FIRCREST PLANNING/BUILDING DEPARTMENT STAFF REPORT

CASE NUMBER 22-03

Development Regulation Text Amendment

September 20, 2022, Planning Commission Meeting

EX 1: Graphic Comparison Regulating Plan (Current and Proposed)

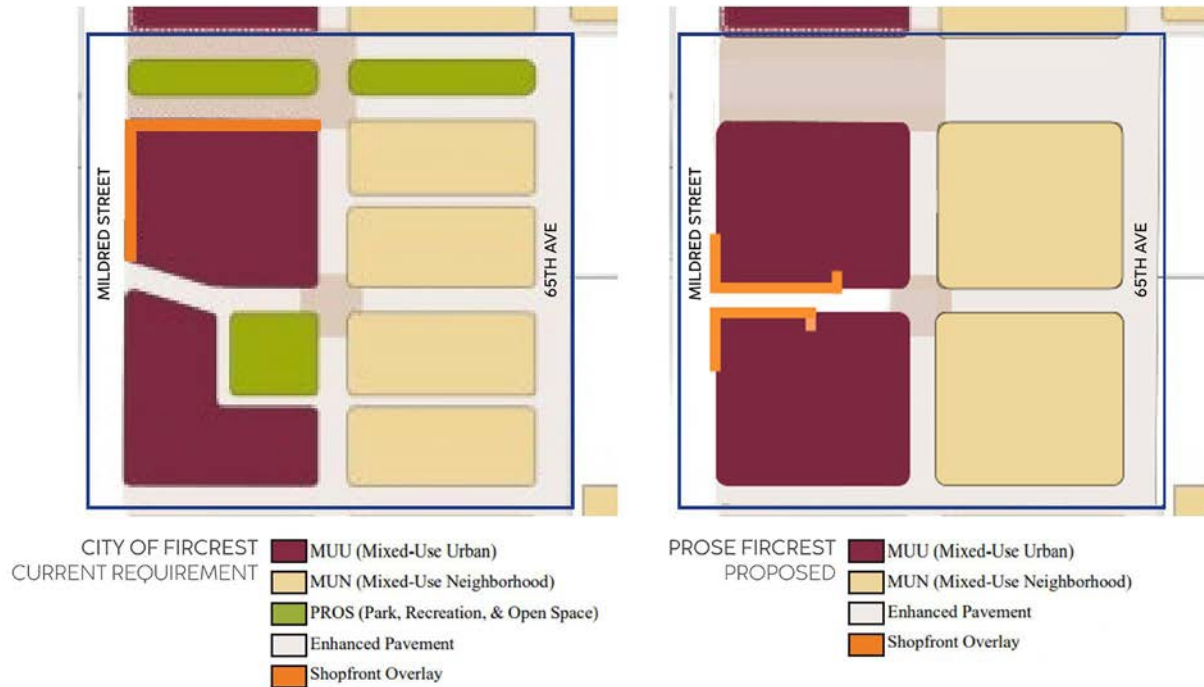
3. (08/16/2022) **Figure RP.1** – The regulating plan map (and zoning map) needs to be amended to reflect the proposed site plan for the Prose development. This would entail shifting street locations and eliminating alleys. It would also affect zoning classification boundaries.

3. (08/16/2022) **Figure RP.1** – The regulating plan map (and zoning map) needs to be amended to reflect the proposed site plan for the Prose development. This would entail shifting street locations and eliminating alleys. It would also affect zoning classification boundaries.
